CORRIGENDUM-2 TO TENDER SPECIFICATION BHEL: PSSR: SCT: 1956

Sub: Erection & Testing of Sea water piping system and all associated Piping in tunnel, buildings & buried portion including related civil works like excavation, sand filling, construction of Inspection chamber at Kudankulam Nuclear Power Project Unit 3 & 4 Tamilnadu.

B. The following clarifications have been sought in regard to subject tender and BHEL's reply is furnished below for information.

PCB 34 LINE FLANGE JOINT ACCESS WELL
NEAR 1 UQA AND 2 UQA

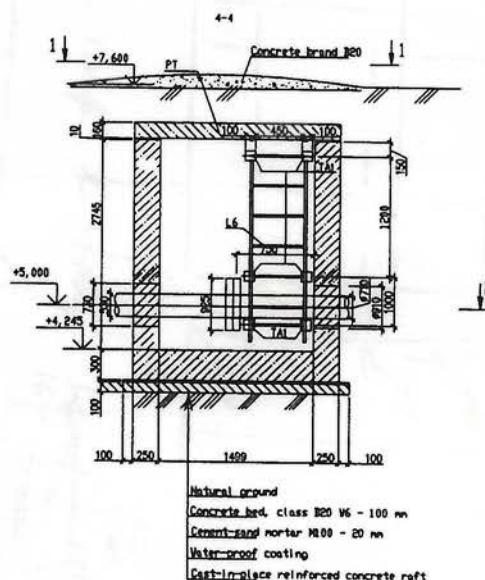
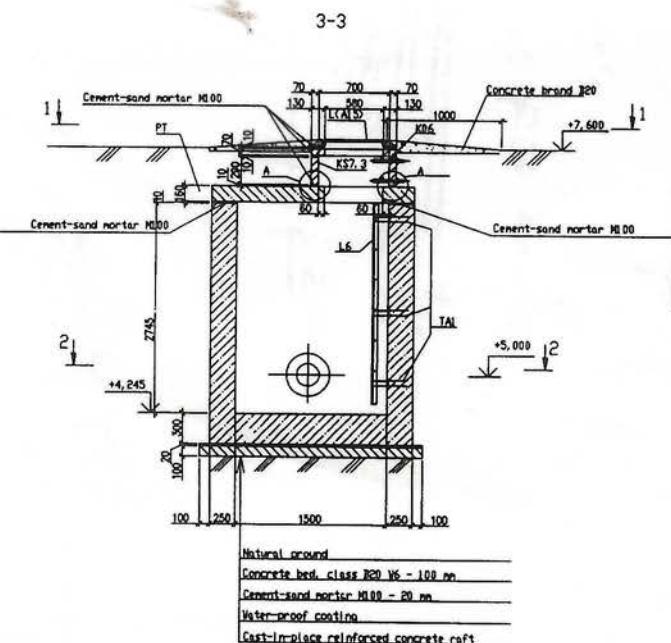
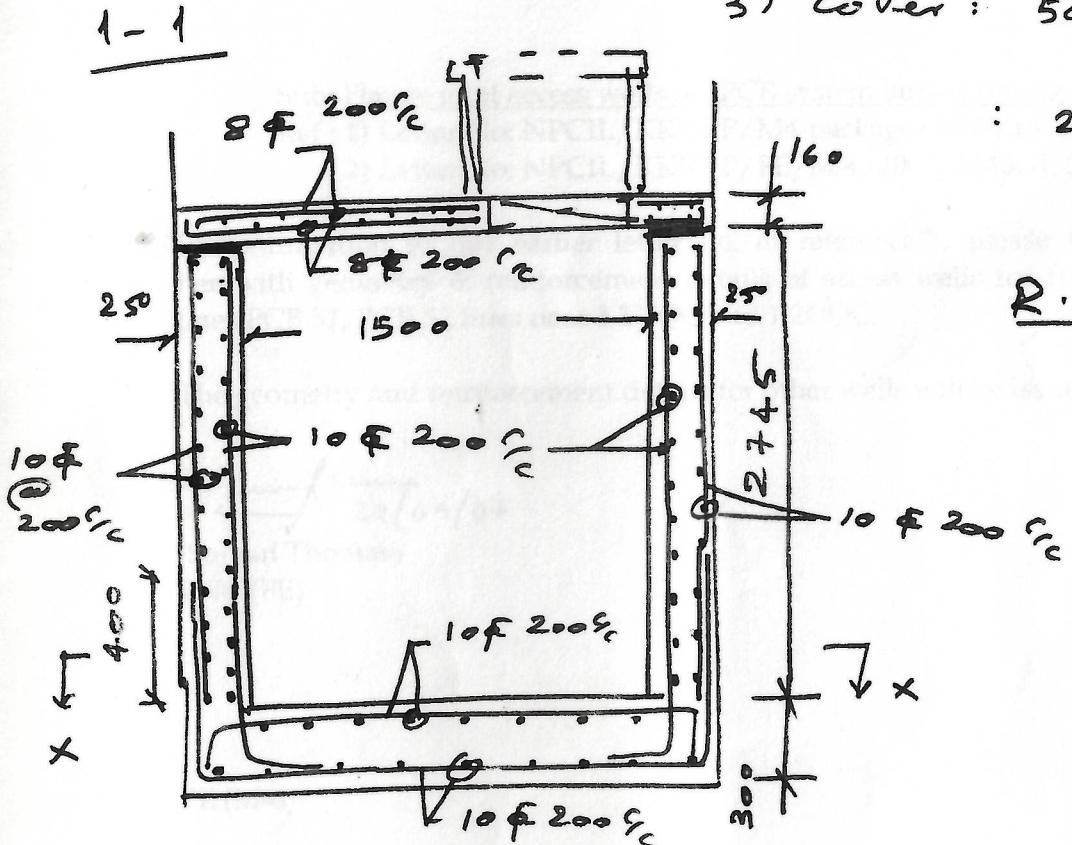
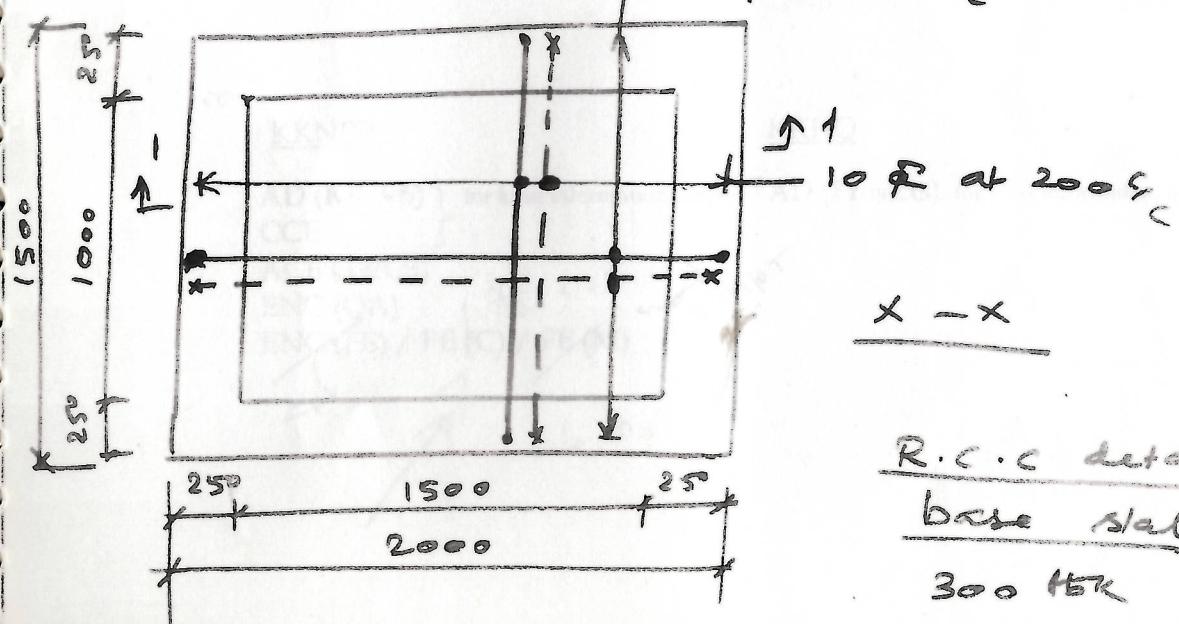
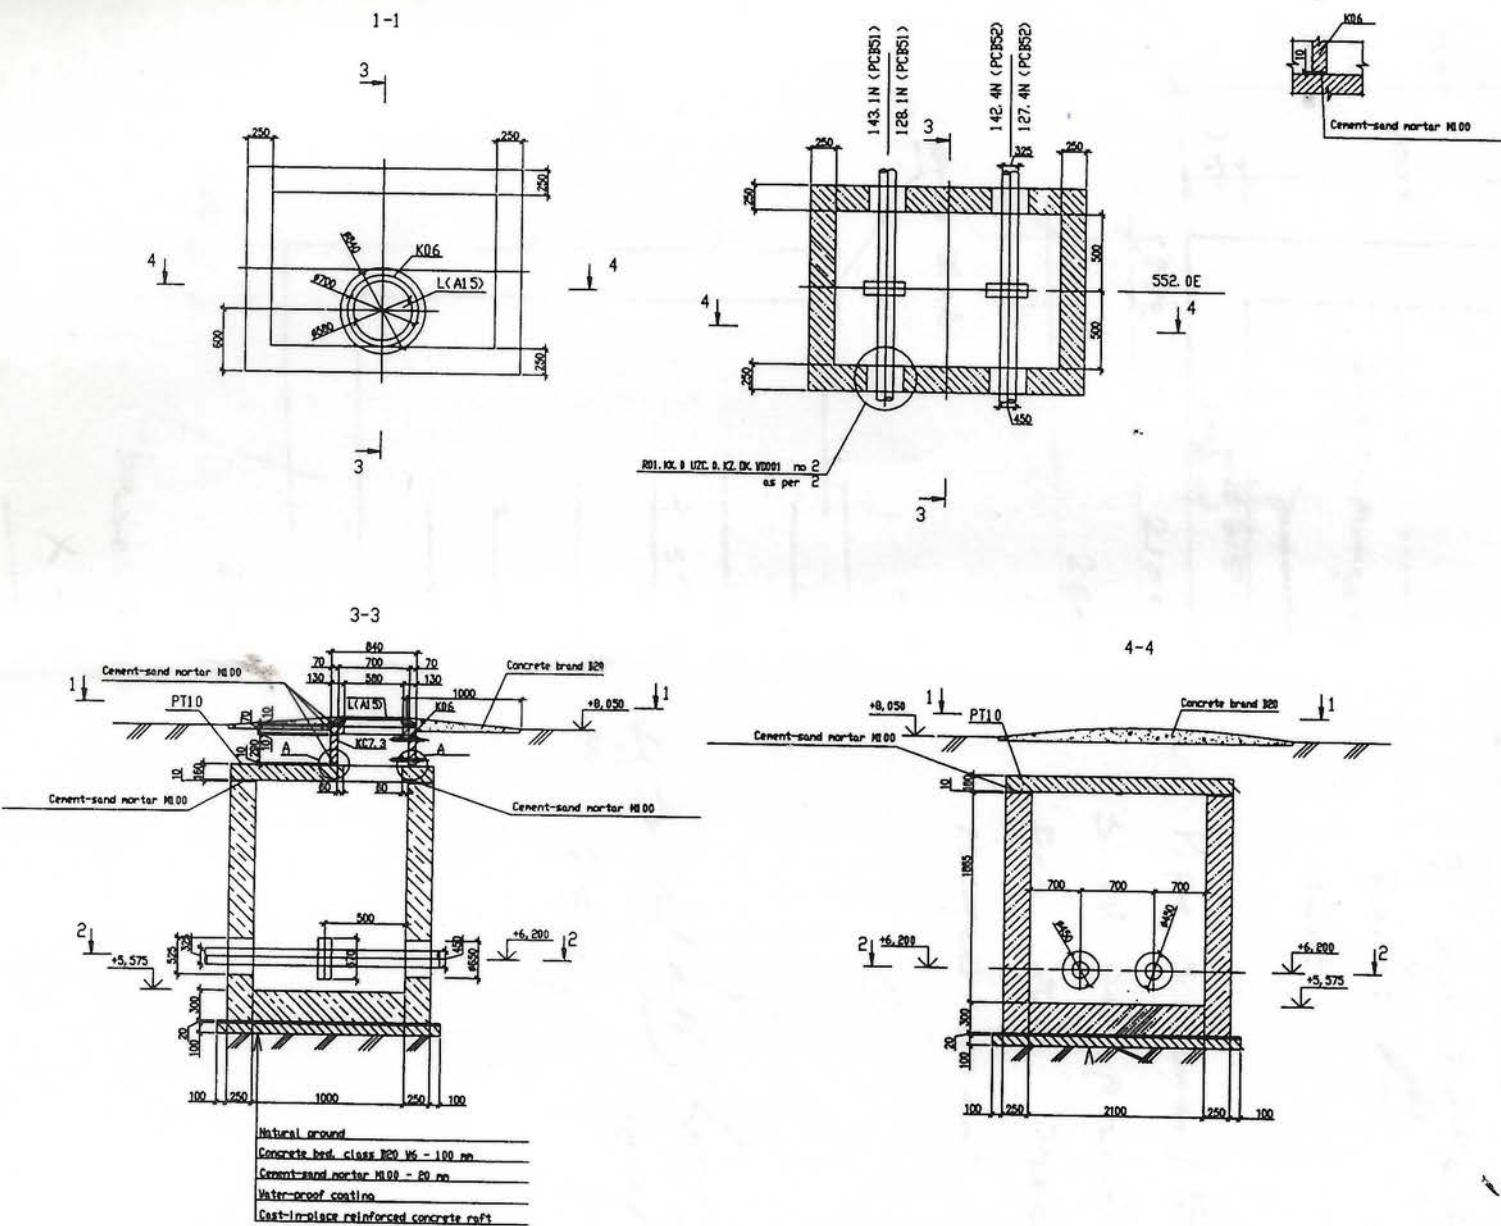
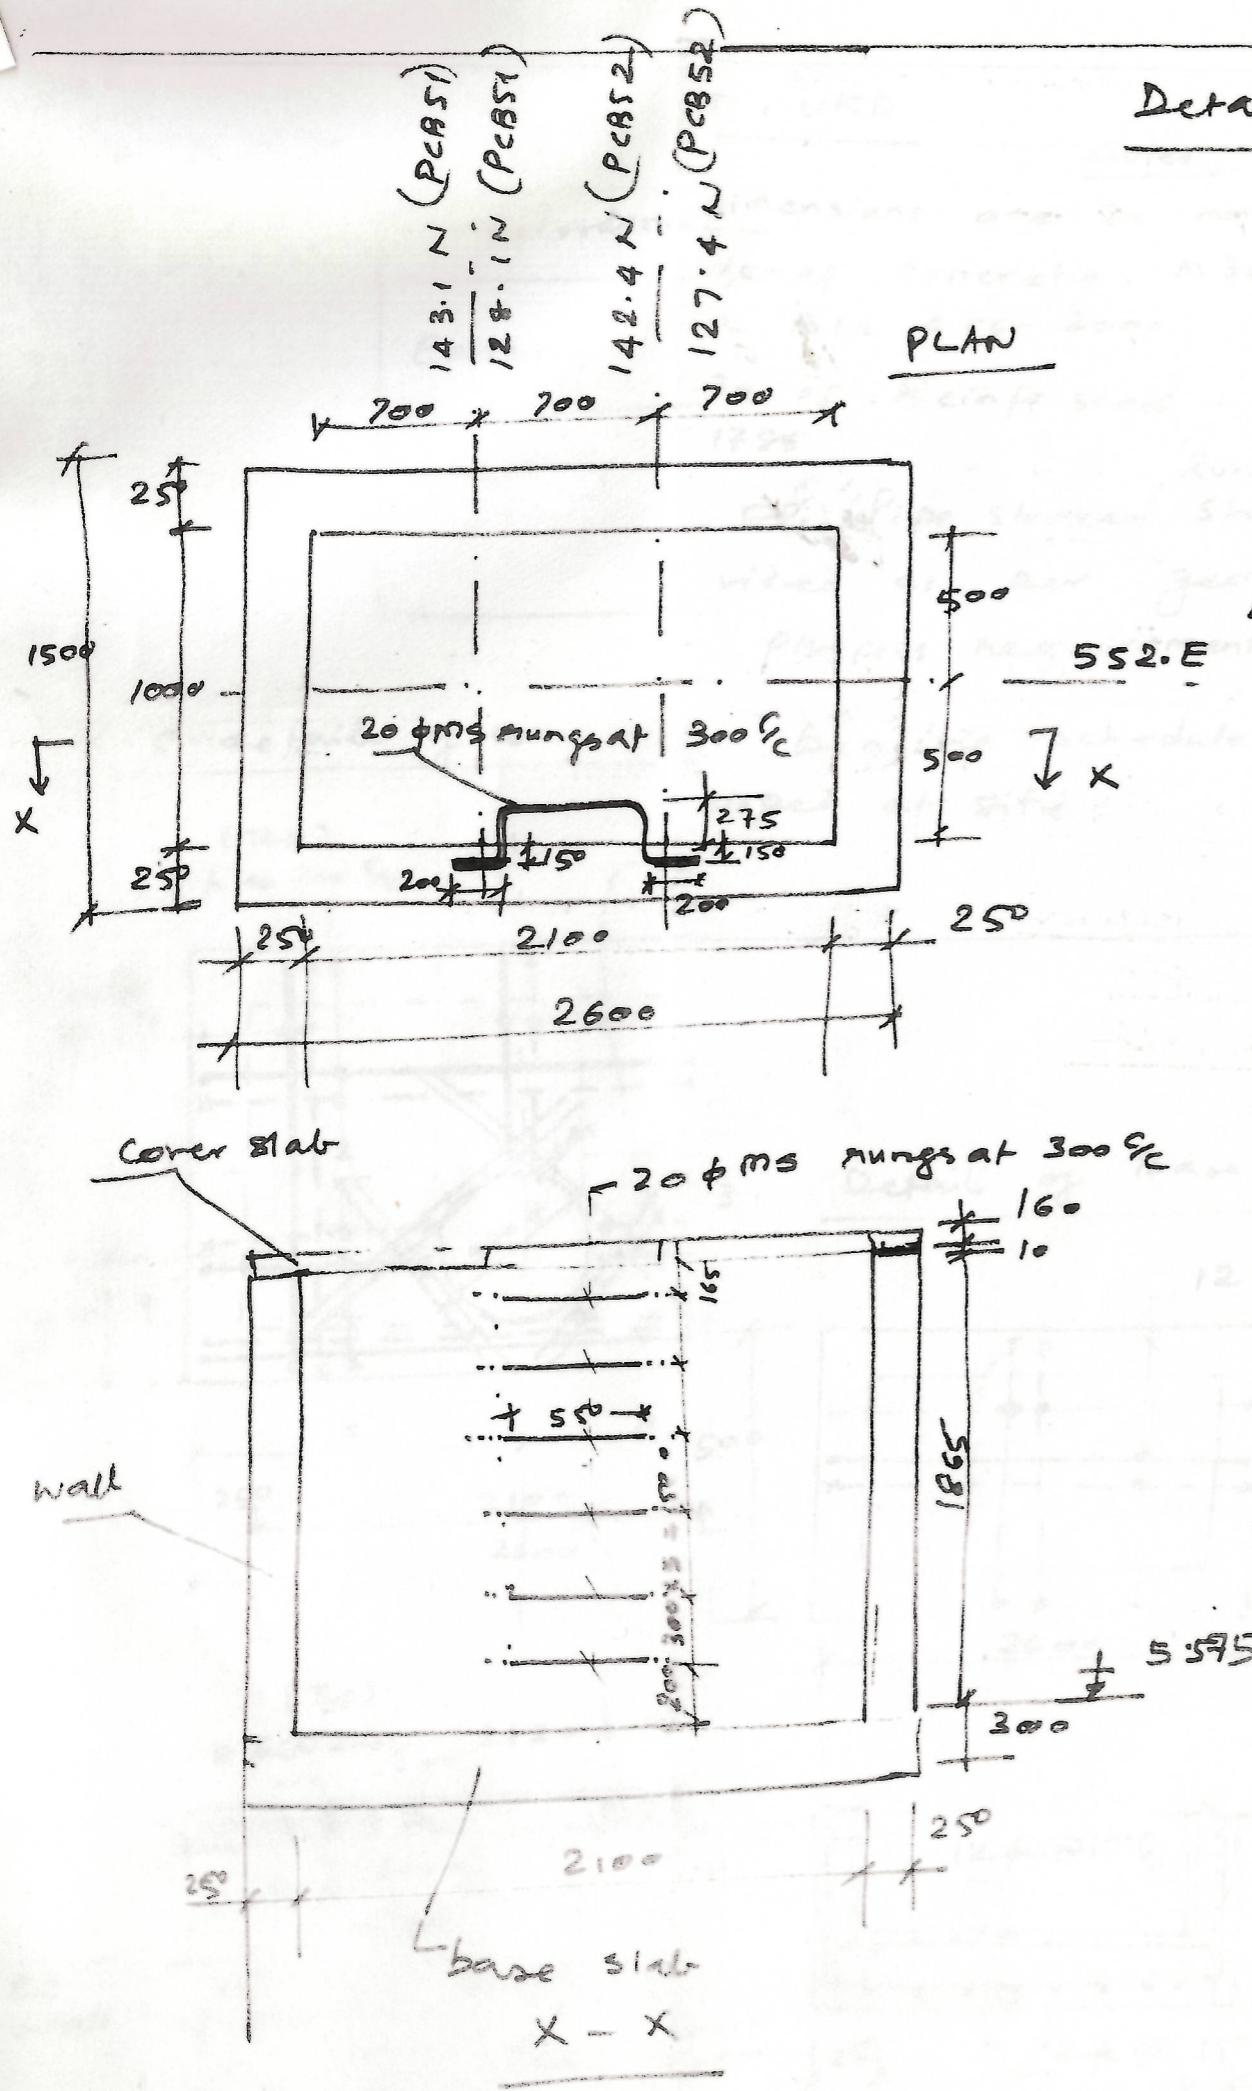
3.	(TCC) VOLUME-IA PART-I & II Clause 1.2.15.4 Page 55 of 402	Civil - Inspection chambers	Please provide all the necessary detail, drawings with Specification and type of chamber water proofing to be carried out.	Sample drawings for inspection chamber is attached for reference as Annexure 1 . Detailed drawing to be submitted by contractor for NPCIL approval during execution.
